American Electric Power

Meeting with

Nuclear Regulatory Commission

Discussion of Containment
Subcompartment Walls

■ Ice Condenser Support Interference and Asbestos Limited to 126° Wall

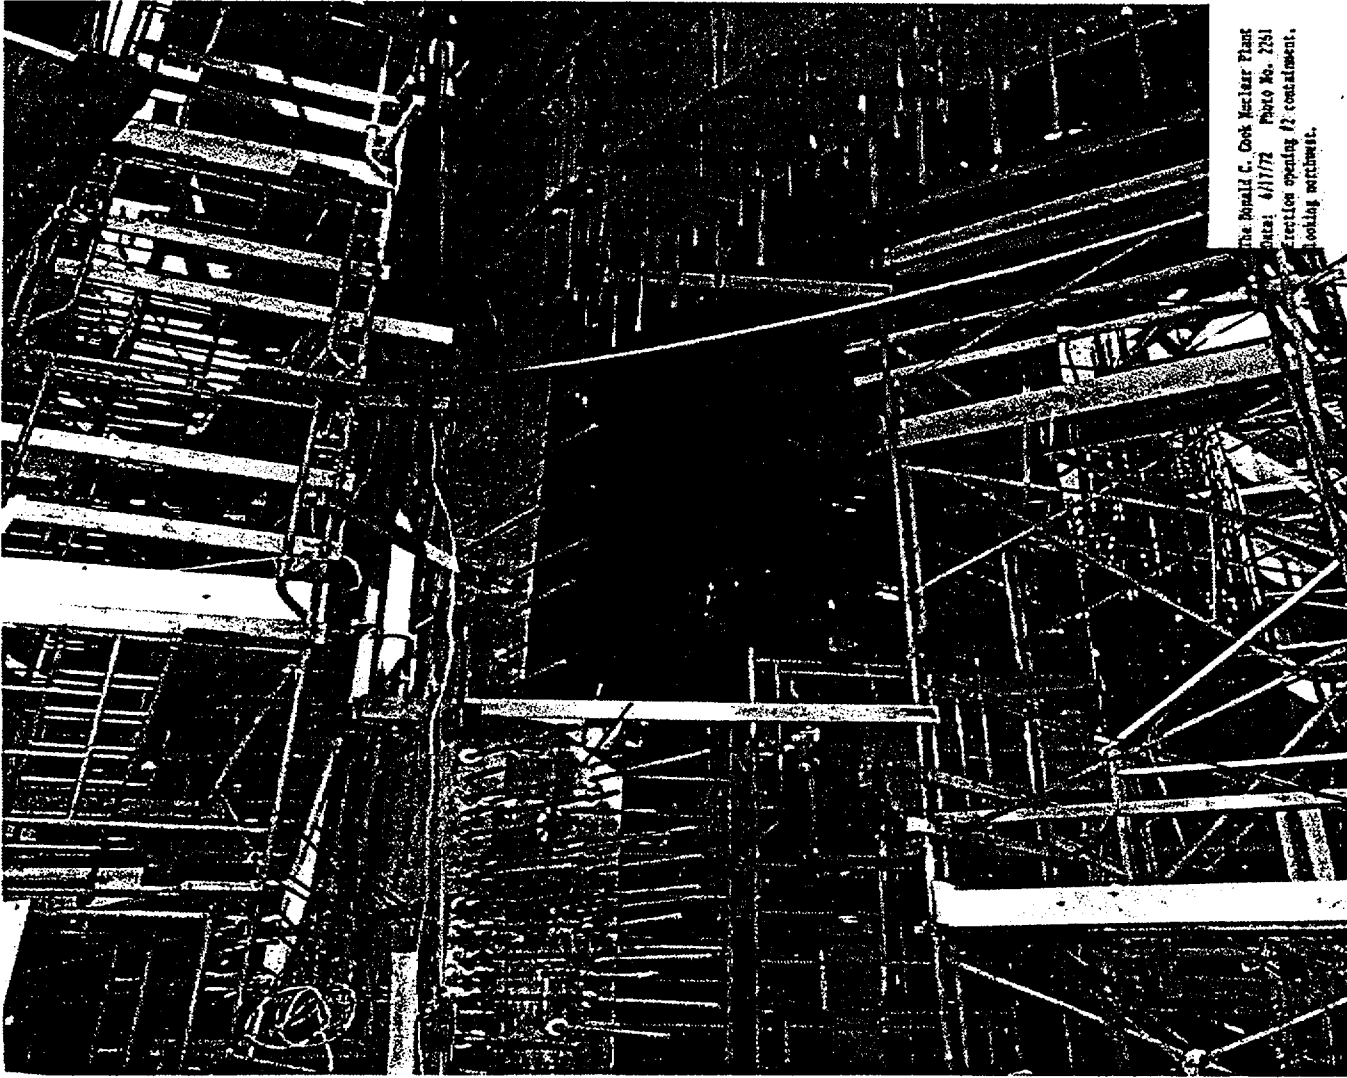
? what do I
chopping any
other wall

Second time telling us this, hope this time
its correct
